NTS 02-E & NTS 03-E Firmware Release Notes

Figure 1 NTP Broadcast/Multicast Rate Selection in ConfigToolIII 4.3.1.1 and later.

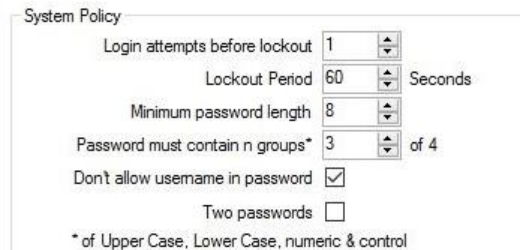
- **Improvement:** Modified NTP broadcast and multicast periods to be expressed in raw seconds, rather than powers of two. This will allow a wider range of options than previously available but excludes rates of more than one message per second.

When upgrading the intervals will automatically be converted from the earlier format and any intervals of less than one second will be rounded up to one second.

ConfigToolIII 4.3.1.1 is required to select or view the full range of intervals.
